Record of Decision  
Final Environmental Impact Statement  
FHWA-MI-EIS-03-01-F  
Proposed Widening and Reconstruction  
I-75 from M-102 to M-59  
Oakland County, Michigan

# **RECORD OF DECISION**

## **Proposed I-75 Widening and Reconstruction from M-102 to M-59 Oakland County, Michigan**

**FHWA-MI-EIS-03-01-F**

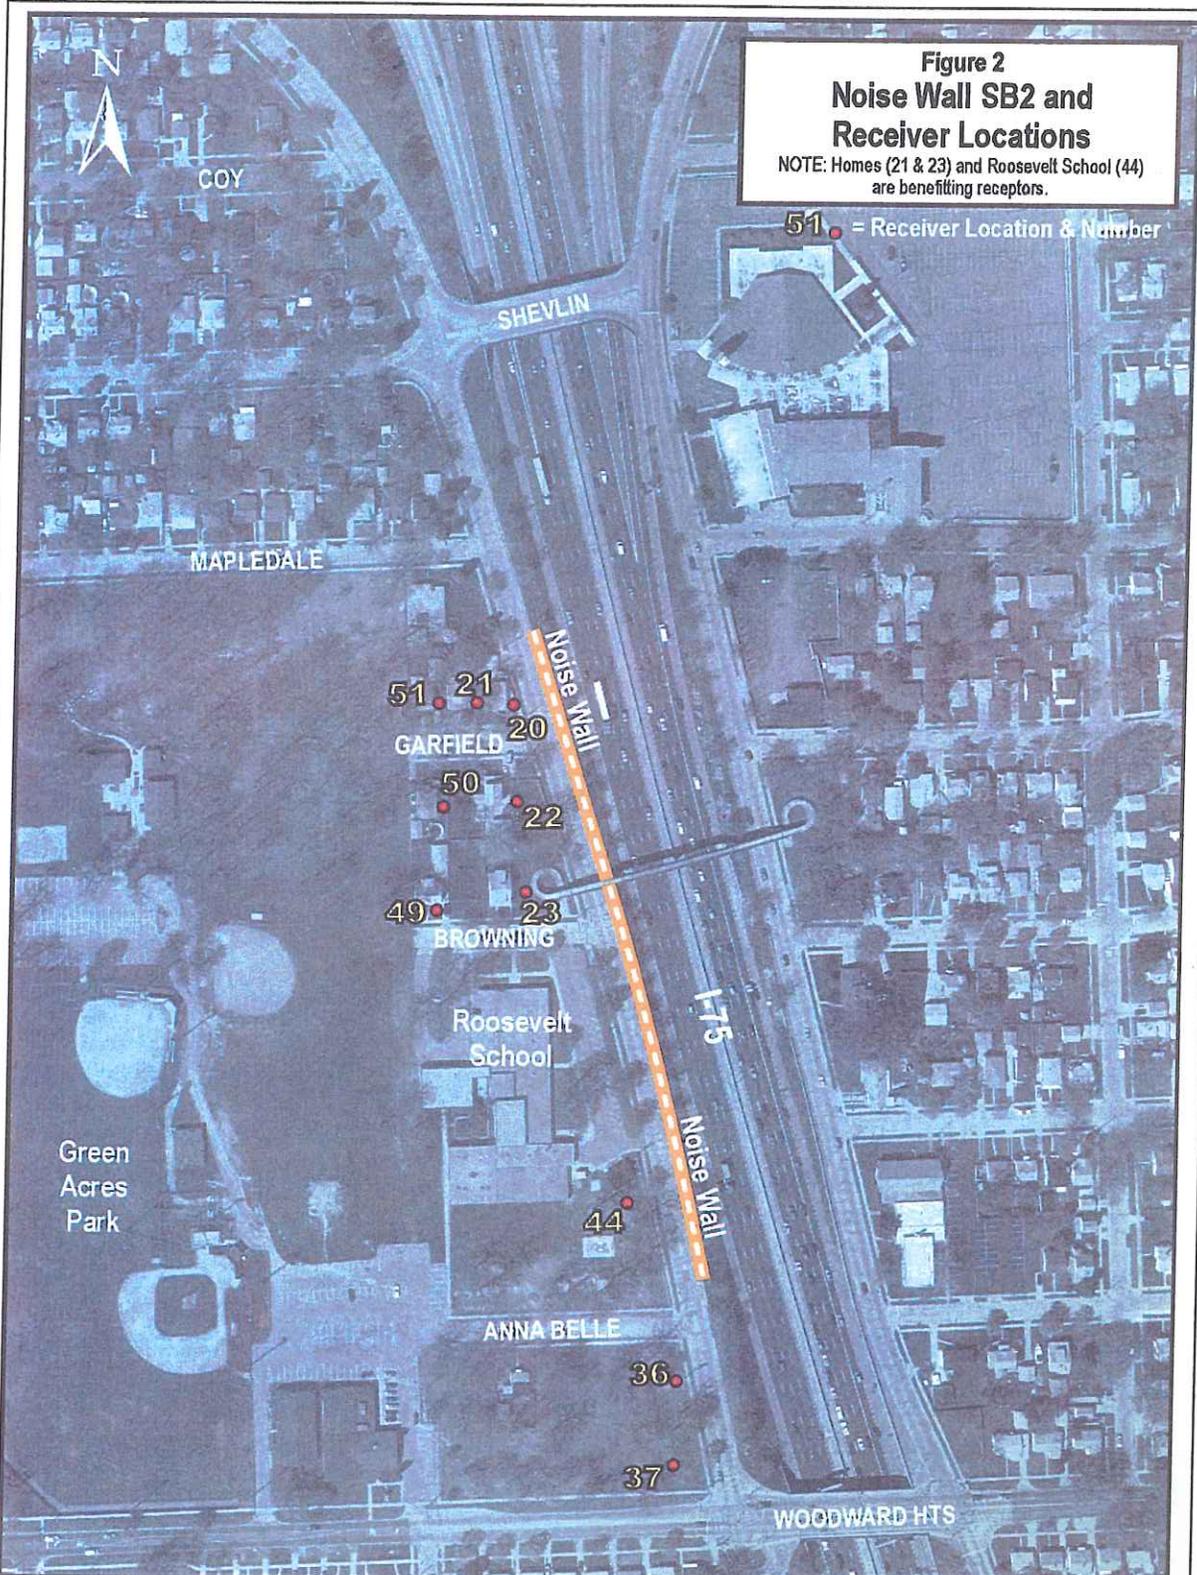
Comment: Comments were received from citizens at the public meeting of July 19, 2005 related to noise, and a letter was received from the City Manager of Hazel Park asking that a sound barrier wall be reevaluated between Woodward Heights and I-696, citing new home construction in the area.

Response: A reevaluation of the data and results in the southwest quadrant of I-696 and I-75 was undertaken and a reconfiguration of the FEIS noise wall was found reasonable and feasible. During the course of the study, elements of Michigan's Noise Policy were clarified. Churches and schools were given special status, but the method of calculating benefits changed over the course of the project. In the final analysis, churches and schools may be counted as the equivalent of 10 dwellings units in determining whether walls are reasonable and feasible. But to be counted in this manner, they must have an adjacent benefiting dwelling unit.

In the FEIS, wall SB2 was not considered reasonable and feasible. A review of the analysis found that by adjusting wall SB2, two homes north of the school can benefit, which allows the school to be counted as ten units. (Figure 2 shows the homes and the extent of the revised wall.) The homes are on the north side of West Garfield and north side of West Browning Avenue. The latter street separates the school from the residences to the north. Thus, wall SB2 is now considered reasonable and feasible.

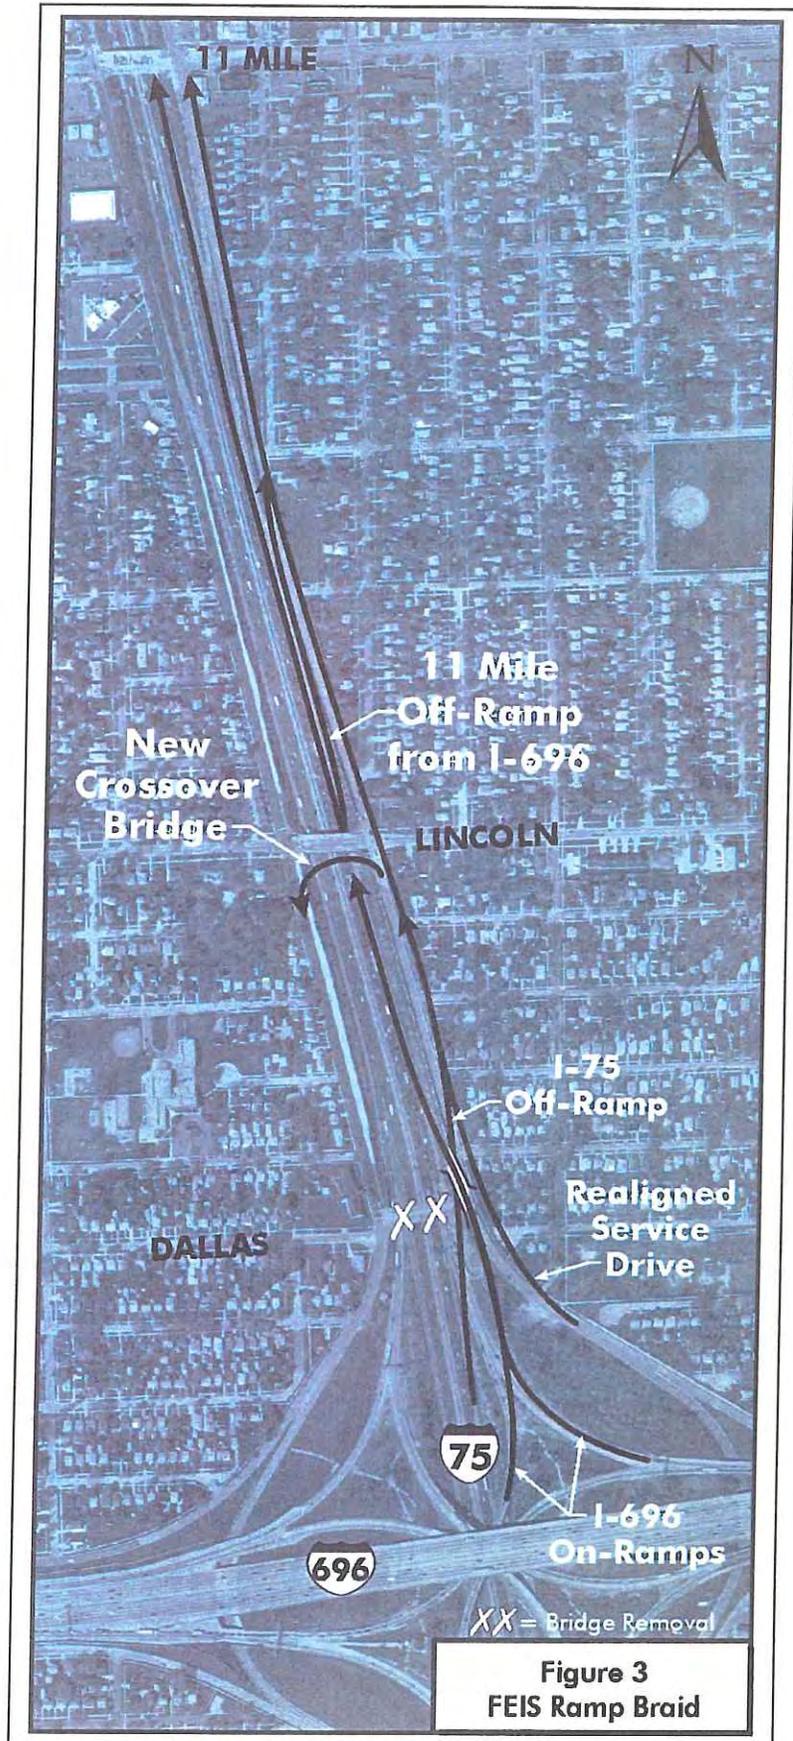
Comment: A city of Royal Oak resolution dated August 1, 2005, states, "Therefore, be it resolved that the City of Royal Oak wishes to reserve the option of not having the Lincoln Bridge rebuilt amongst other possible considerations." Two letters, four emails, and 39 opposition forms were submitted, principally by those living on, or near, Lincoln Avenue in Royal Oak. The Oakland County Board of Commissioners adopted Resolution #05148, August 18, 2005, recommending that MDOT "address and mitigate the effect of additional traffic on Lincoln in the possible design of the Lincoln Road exit."

Response: These comments are based on a concern that the revised FEIS braid design (Figure 3) will increase westbound traffic on Lincoln Avenue in Royal Oak. Braiding the I-75 northbound off ramp and I-696 on ramps to prevent conflicts in the resulting weave area was found to be the single most important component to travel flow and safety of the Selected Alternative. Of the 18 one-way project miles, this section of I-75 has the third highest crash rate of any section between M-102 and M-59, and the section to the south has the second highest crash rate.
